CITY OF LOS ANGELES
INTER-DEPARTMENTAL CORRESPONDENCE

22815-22825 W Roscoe Blvd.
DOT Case No. SFV21-111390
DOT Project ID No. 51619

Subject: **TRANSPORTATION IMPACT ASSESSMENT FOR THE FALLBROOK POINT PROJECT
LOCATED AT 22815-22825 WEST ROSCOE BOULEVARD (DIR-2019-7507-ACI-
CLQ/ENV-2019-7508-CE)**

Attachment C Project Site Plan

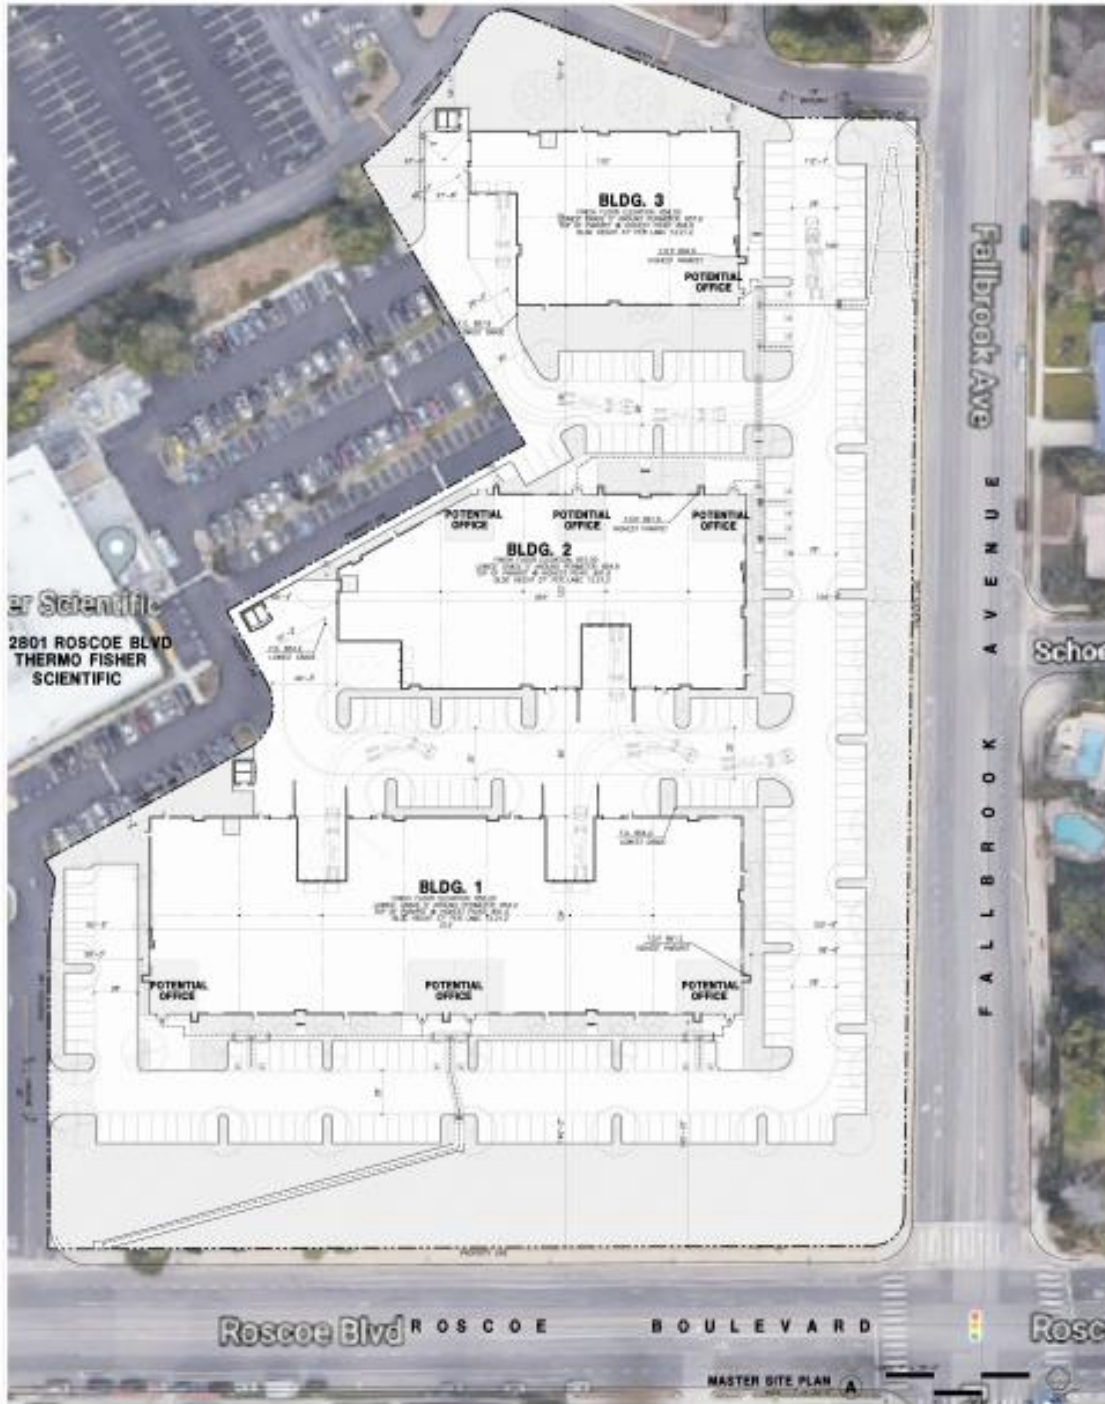
Vehicular access will be provided via the existing driveway along the west side of Fallbrook Avenue and the existing driveway along the north side of Roscoe Boulevard. Additional vehicular access to the project site will continue to be provided via the existing driveway along the north side of Roscoe Boulevard, opposite Lena Avenue. The driveways serving the project site will continue to accommodate full vehicular access including left-turn and right-turn ingress and egress movements. The project site plan is shown in **Attachment C**. The applicant should check with City Planning regarding the Project's driveway placement and design. The review of this study does not constitute approval of the existing driveway dimensions, access, and circulation scheme with regard to this project. Those elements require separate review and approval and should be coordinated with LADOT's Valley Planning Coordination Section (6262 Van Nuys Boulevard, Rm 320, @ 818-374-4699). To minimize and prevent last-minute design changes, the applicant should contact LADOT before the commencement of building or parking layout design efforts, for driveway width and internal circulation requirements. New driveways should be Case-2, designed with a recommended width of 30 feet for two-way operations, or 16 feet for one-way operations, or to the satisfaction of LADOT.
